# Metro Central Joint Development Assessment Panel Agenda

Meeting Number: MCJDAP/253

Applicant: Planning Solutions
Owner: Amtank PTY LTD
Responsible authority: Town of Bassendean
DAP File No: DAP/17/01224

Property Location:	Lot 125 (No. 3/335) Collier Road,	
Troporty Location	Bassendean	
Development Description:	Proposed Convenience Store	
DAP Name:	Metropolitan Central JDAP	
Applicant:	Planning Solutions	
Owner:	Amtank PTY LTD	
Value of Development:	\$2.1 million	
LG Reference:	DABC/BDVAPPS/2017-087	
Responsible Authority:	Town of Bassendean	
Authorising Officer:	Dylan Stokes, Planning Officer	
Department of Planning File No:	DAP/17/01224	
Report Due Date:	8 August 2017	
Application Receipt Date:	25 May 2017	
Application Process Days:	75 days	
Attachment(s):	Applicant's Development Application	
/ titadimioni(o)	Report prepared by Planning	
	Solutions submitted on 24 May 2017.	
	, , , , , , , , , , , , , , , , , , , ,

Figure 4: Fuel tanker turn path analysis

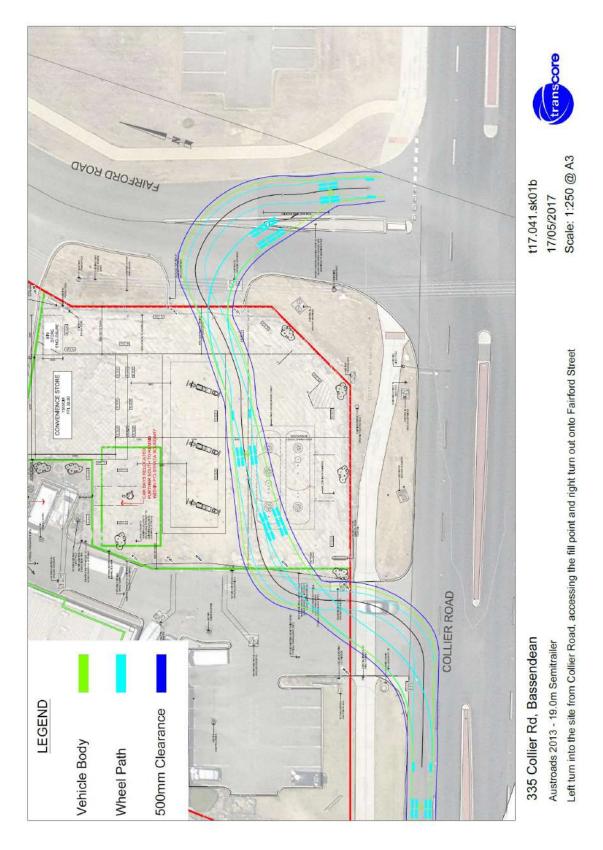
A plan depicting the swept path movements of a 19.0m fuel tanker and 8.8m service vehicle is contained in **Appendix 4**, refer to Figures 4 - 6. The TIS identifies that the northern section of the existing solid median along Fairford Street will need to be removed and replaced with appropriate road line-markings.

As shown in Figure 4, the fuel tankers are expected to turn left into the site from Collier Road and traverse within the southern aisle towards the fill point. After the filling operation the fuel tankers are expected to leave the site via a right turn out onto Fairford Street towards Collier Road. According to Figure 4 the northern section of the existing solid median along Fairford Street should be trimmed to accommodate the proposed right turn out movement of the fuel tankers.

In order to permit the fuel vehicle to exit from the Fairford Street crossover, modifications will be required to the existing median strip in Fairdord Street. The Town supports the modifications of the median strip on Fairford Street as shown on the plans at the full expense of the applicant. A condition of approval has been recommended to this effect.

Vehicle Maneuvering Plan - 19m Semitrailer - Right hand turn (red) into the site from Collier Road

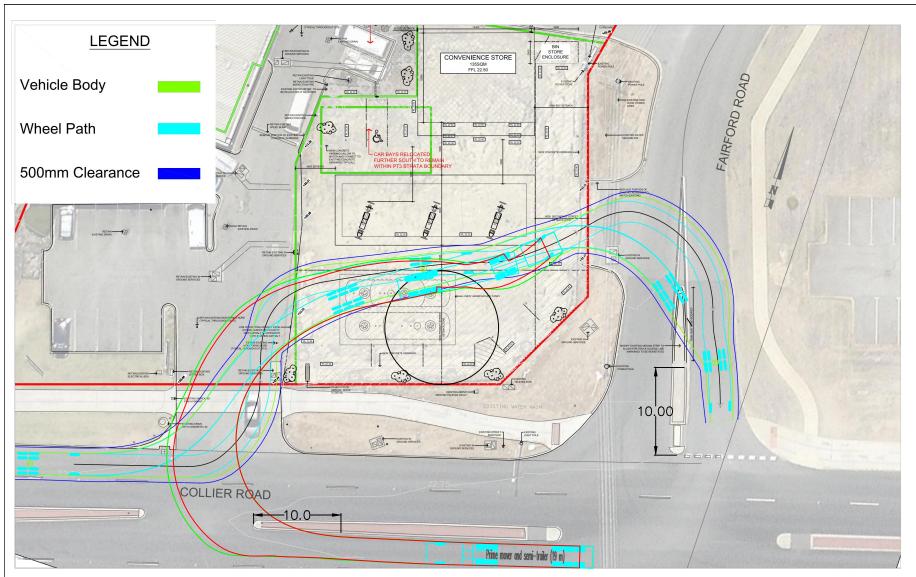
- 1. This approval is for the use of the building as a Convenience Store only. Any alternative use of the premises will require the submission of an application to the Town for a change of use.
- 2. Revised drawings shall be submitted in conjunction with the application for a building permit and such drawings shall demonstrate:
  - a. A reduced height to Price Board sign from 7m to a maximum height of 6m.
  - b. The bin area is to be masonry in construction and equipped with a hose cock. The floor must be graded to a floor waste and connected to sewer.
  - c. A replacement crossover to Fairford Street incorporating a 5m turning radius for both the crossover wings.
  - d. The median strip on Collier Road is to be modified to be flush for a length of 10m as shown on the approved turning template to allow fuel vehicles to turn right from Collier Road and adequately enter the site.

Due to the confined nature of the site, access is required from Collier Road to allow the 19.0m fuel trunks to adequately access the site and exit in forward gear. The Department of Planning have indicated in their correspondence that they support the retention of the existing access arrangement to Collier Road, subject to recommended conditions.
